SOIL/SITE EVALUATION
for ON-SITE WASTEWATER SYSTEM

IMPROVEMENT PERMIT DENIAL

Re: Application for improvement Permit for property located at 3815 Baronwood LN, 053-182-07,

Health Department file # 757

3815 Baronwood Lane Recombination Plat

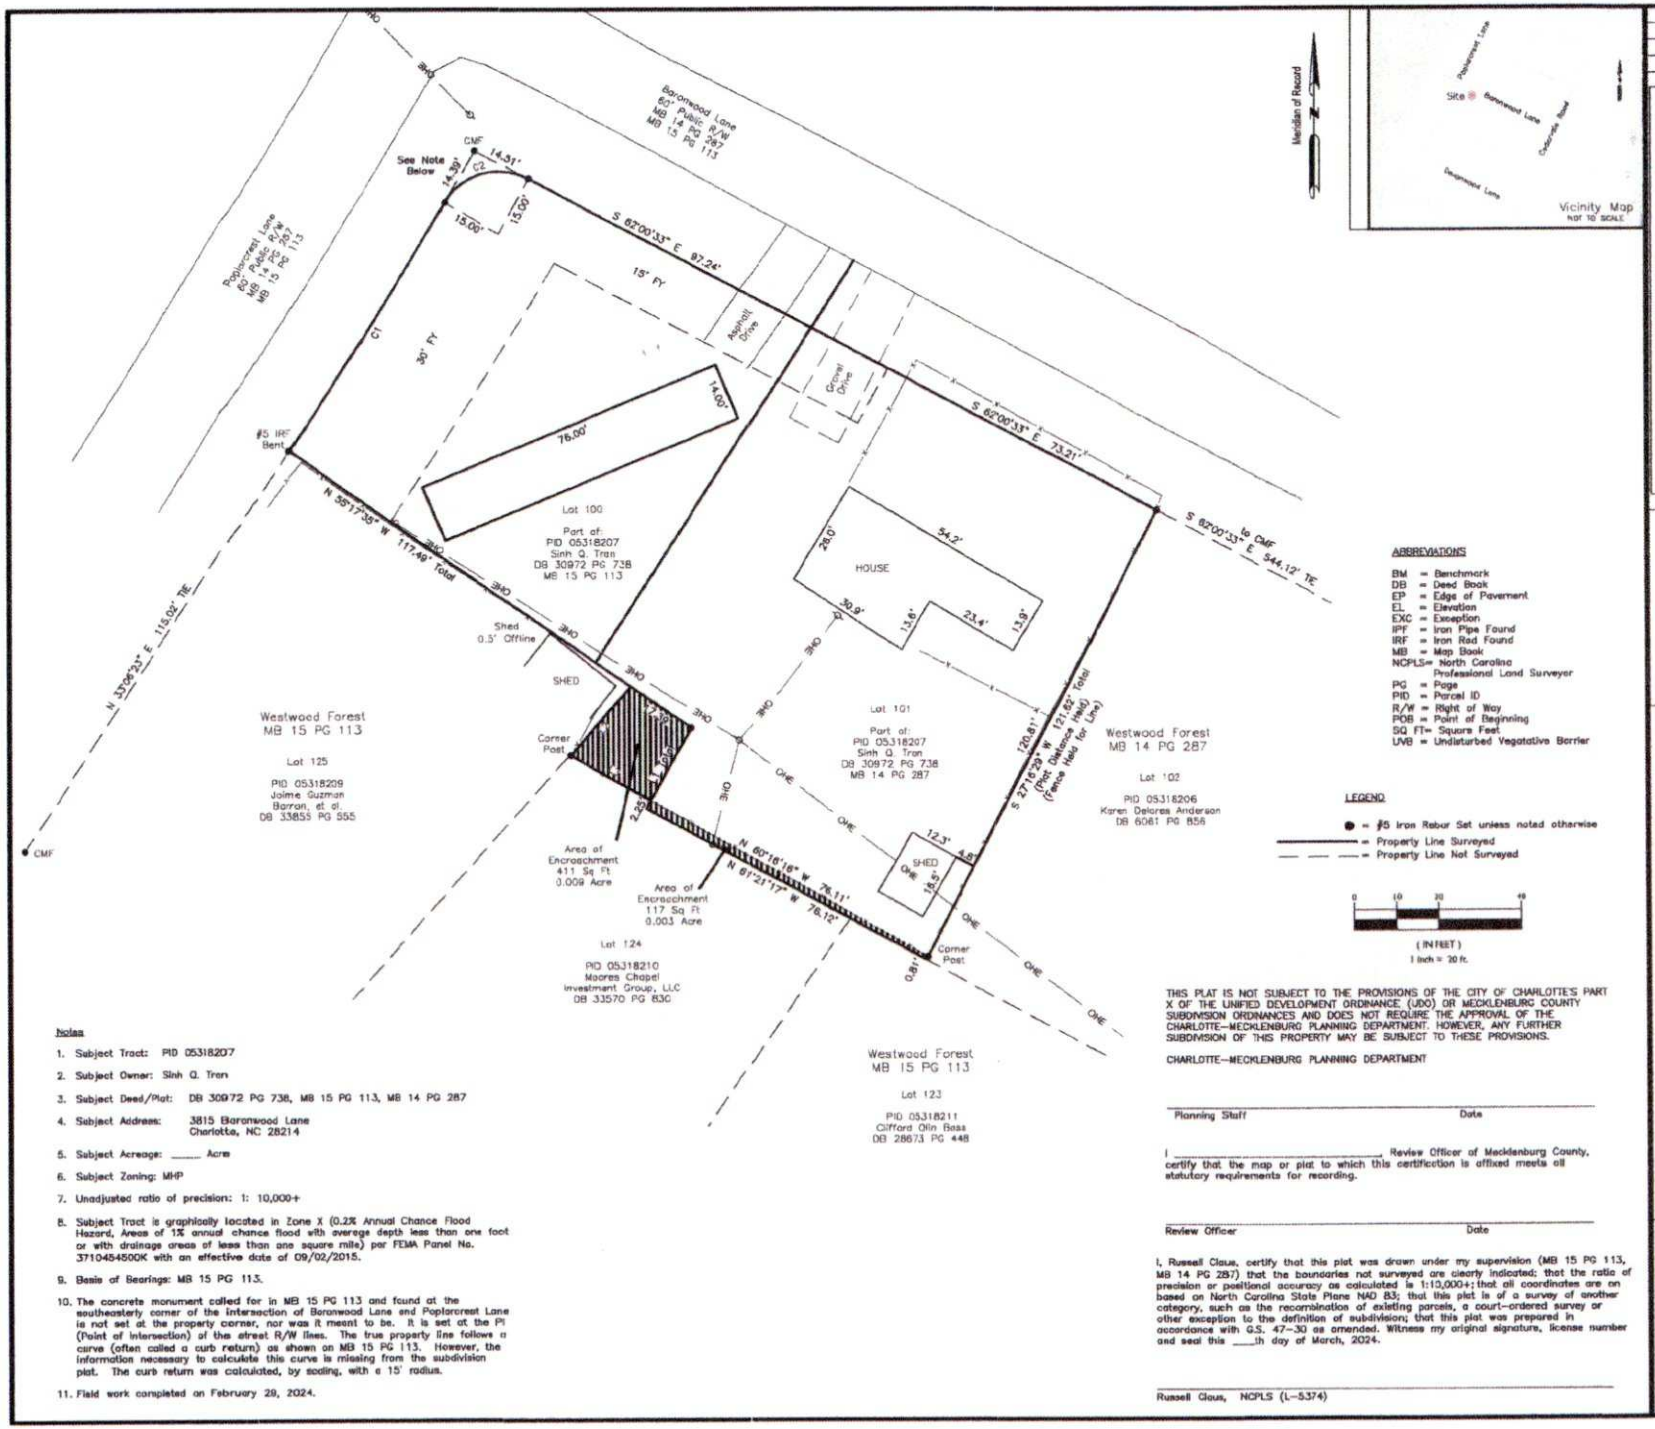
COMMENTS: Unsuitable soil wetness conditions are present, along with potentially unsuitable saprolite, shallow depth to rock(?), and the presence of fill soil materials. In addition, insufficent space due to existing asphalt driveway and Lot 100 only being approx. 0.24 acres.

Based on the criteria set out in 15A NCAC 18E .0501 through .0602, the evaluation indicated that the site is **UNSUITABLE** for an on-site wastewater system. Therefore, we must deny your request for an Improvement Permit. A copy of the site evaluation is enclosed. The site is unsuitable based on the following:

- ☐ Unsuitable soil topography and/or landscape position (Rule .0502)
- ☒ Unsuitable soil characteristics (structure or clay mineralogy) (Rule .0503)
- ☐ Unsuitable soil wetness condition (Rule .0504)
- ☐ Unsuitable soil depth (Rule .0505)
- ☐ Unsuitable saprolite (Rule .0506)
- ☐ Presence of restrictive horizon (Rule .0507)
- ☒ Insufficient space for septic system and repair area (Rule .0508)
- ☐ Unsuitable for meeting required setbacks (Rule .0601 or .0602)
- ☐ Other (*Cite applicable rule*):_____

The site evaluation included consideration of possible site modifications, as well as use of all possible systems approved under 15A NCAC 18E. However, the Health Department has determined that none of the above options will overcome the severe conditions on this site. A possible option might be a system designed to dispose of sewage to another area of suitable soil such as off-site to additional property.
